Accelerator Pedal
VN, VHD, VAH**FSB 271-002, Accelerator Pedal****(December 2013)**

On some Volvo models built between January 1, 2013 and September 13, 2013, may experience multiple counts of inactive faults:

W2083014

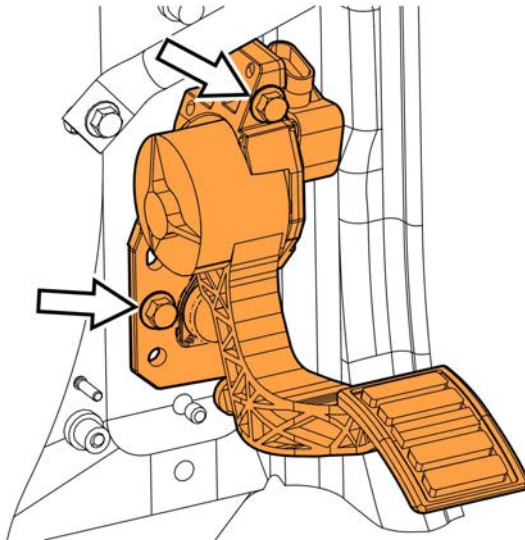
- 8 Install replacement accelerator pedal and tighten fasteners to 24 ± 4 Nm (18 ± 3 ft-lb).

W2083015

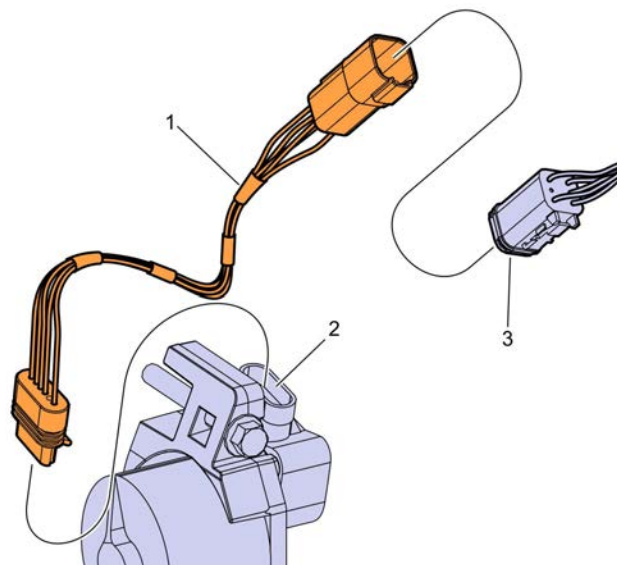
- 9 Connect the jumper harness connector (1) to the throttle position sensor (2) and to the cab harness (3).
